ADDENDUM #1

December 17, 2013

**Fort Mojave Mesa Fire Department
Station 91
Turn-Key Solar Project RFP#13-01
Fort Mohave, Arizona**

E1.1 : file
1324 : project
HMS : drawn
09/06/13 : date
ELECTRICAL PLAN : title

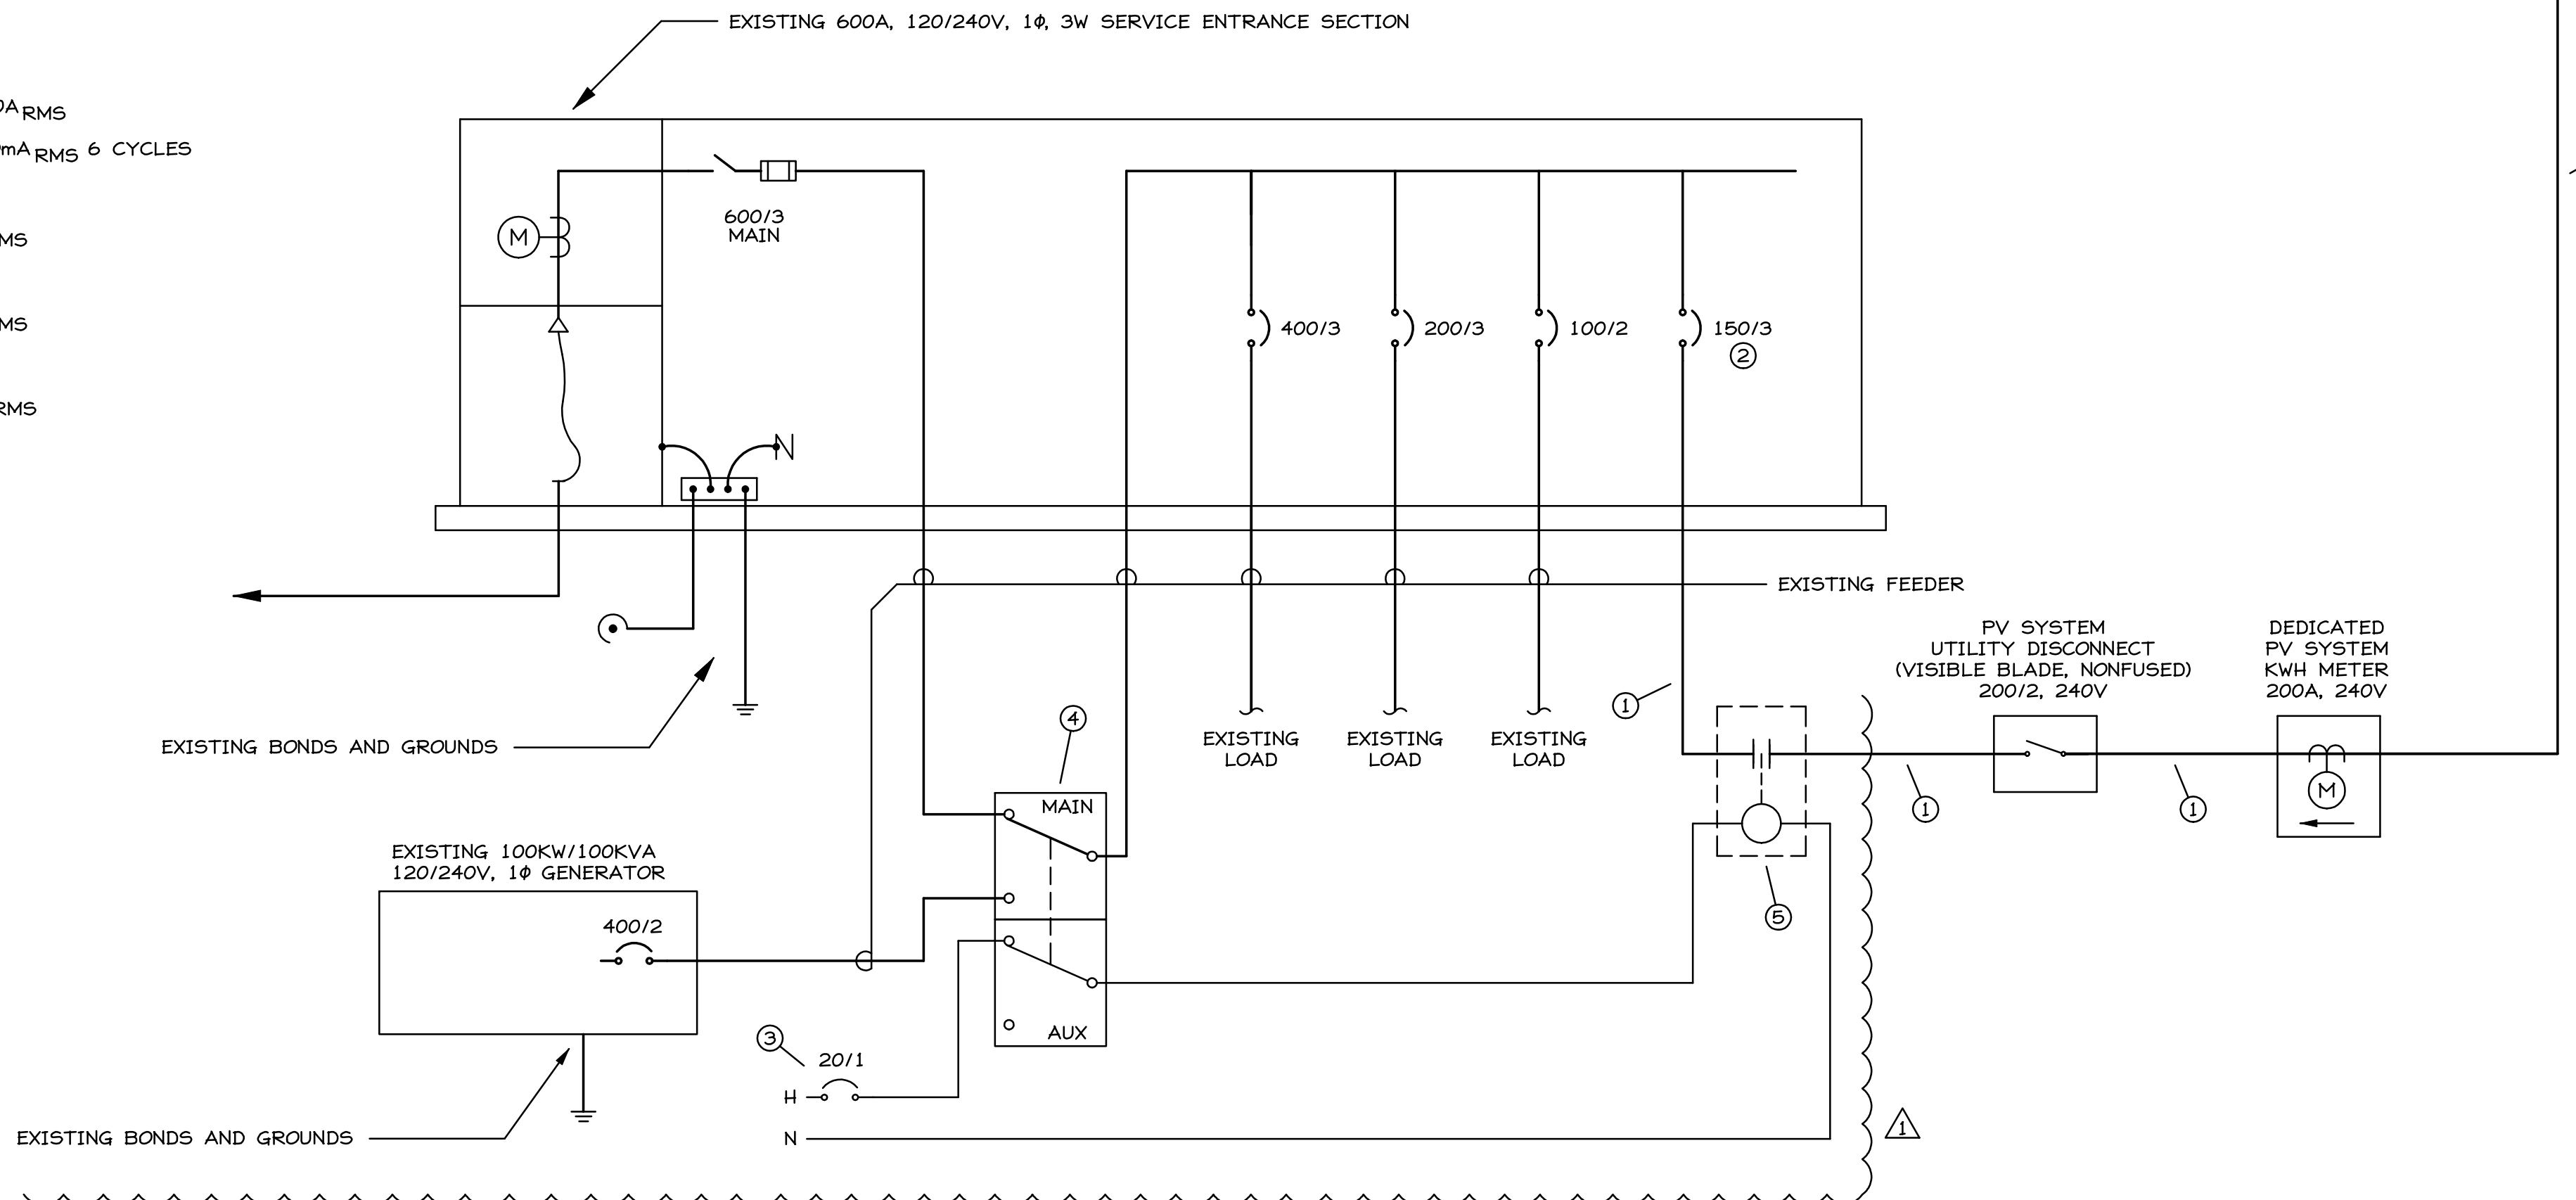
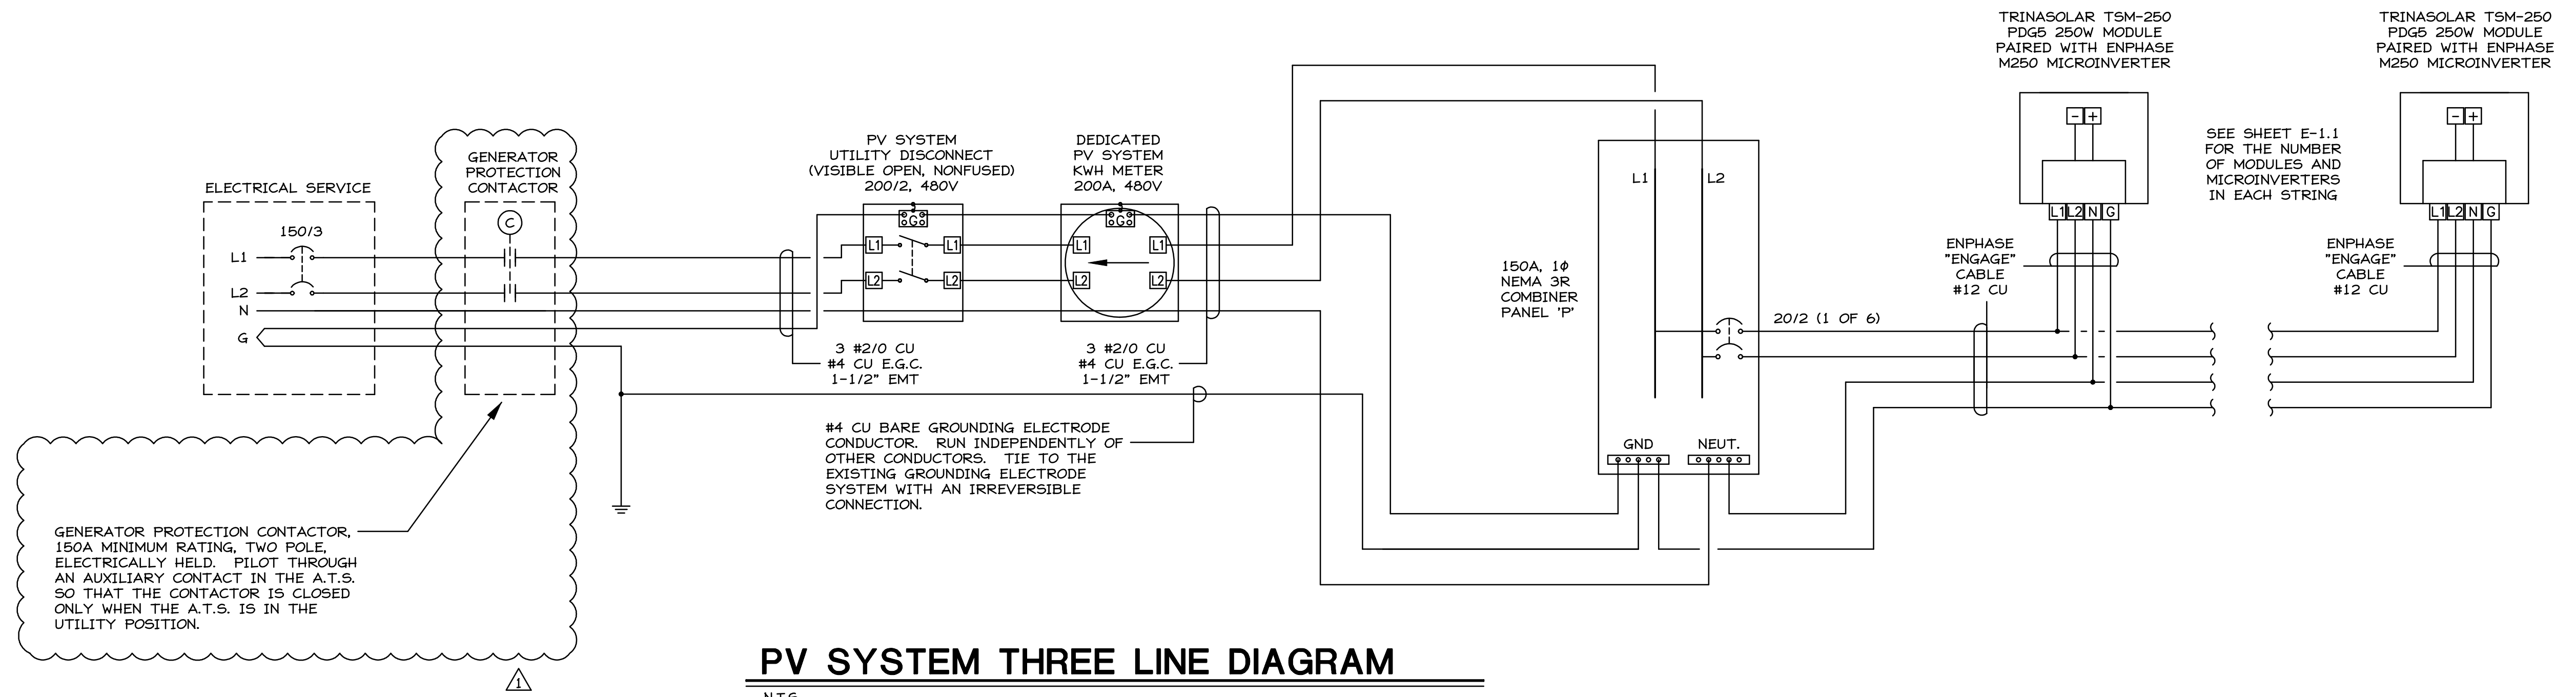
Contractor Question: *The schematic shows a 3-phase service entrance; all the panels are directly south facing. Can we use a single 120/208 3-phase inverter for this system?*

Reply: The service entrance is single phase (see item number 1-7 below). A single 120/208 3-phase inverter is not approved for this system.
